A46 Newark Bypass

7.42 Responses to Written Representations

Responses to Written Representations

Regulation Number:	8(1)(c)(i)
Planning Inspectorate Scheme Reference	TR010065
Application Document Reference	TR010065/APP/7.42
Author:	A46 Newark Bypass Project Team, National Highways

Cross-sections from the D.C.O. drawings show the effect of superelevation:

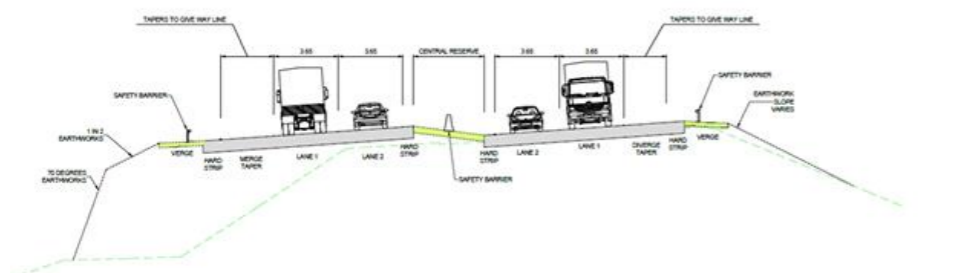
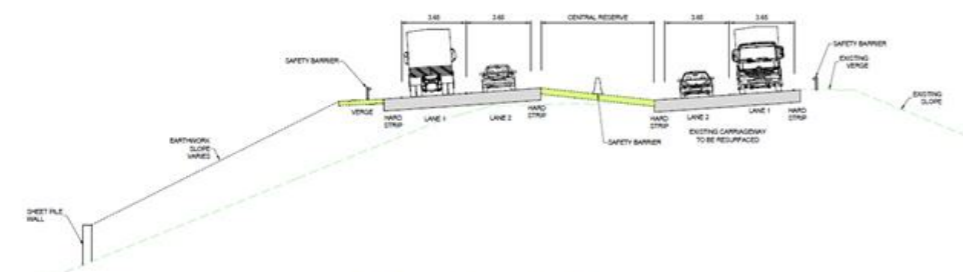
It should be noted that these cross-sections show staggered carriageways, whereas the Applicant's response to the Relevant Representation states that:

The arrangements on the cross-sections H & I above do not seem to co-incide with the plan view shown on the D.C.O. and the Applicant's response that both seem to imply a co-planar arrangement of the new soffit with the old soffit rather than staggered separate carriageway soffits.

The concern here is that the additional bridge span in a co-planar arrangement lowers the effective soffit height when the need is to raise the soffit height to allow the railway grade to commence as early as possible on the exit from the original bridge.

Also in the D.C.O. documents is Elevation 1 showing the additional span:

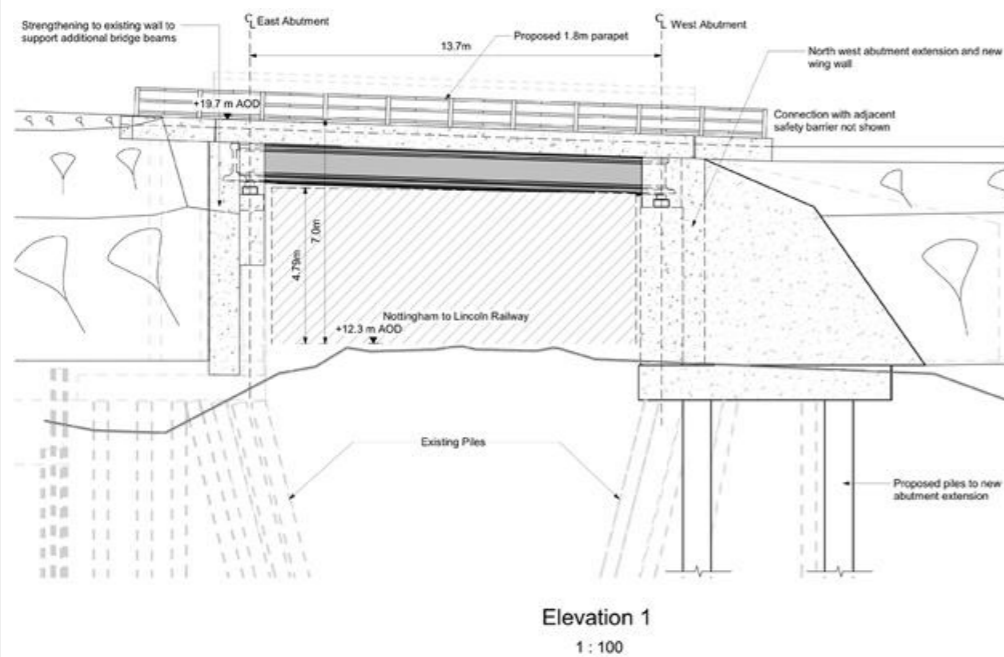
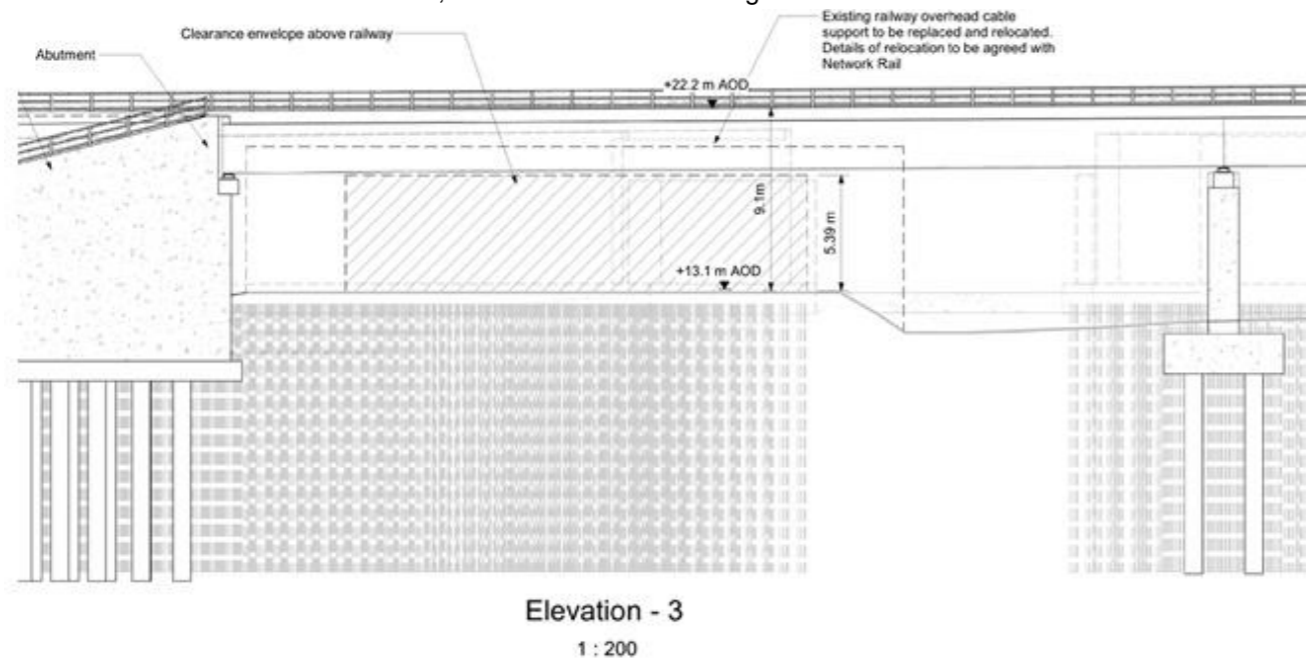
- This shows: -
- a rail height of 12.3m A.O.D.;
 - a maximum rail to soffit height of 4.79m: &
 - a rail to road surface height of 7m.

This gives a construction depth of 2.21m.

It also gives an additional headroom of only 0.01m over the desirable minimum soffit height of 4.780m for the standard structure gauge.

In effect the D.C.O. Elevation 1 shows the soffit height at the new widened northern side of the bridge and the Jacobs 2016 Report shows the soffit height at the original southern side of the bridge. The difference in soffit height might be explained by the co-planar arrangement of carriageways due to the super-elevation of the road.

Thus there appears to be some incompleteness in the basic information supplied in the D.C.O. documents and also in the Atkins 2022 report with regard to the A46 East bridge over the railway.

The provision of a General Arrangement drawing of the complete bridge with the headroom and soffit heights at the existing side and the widened side shown would answer these concerns.
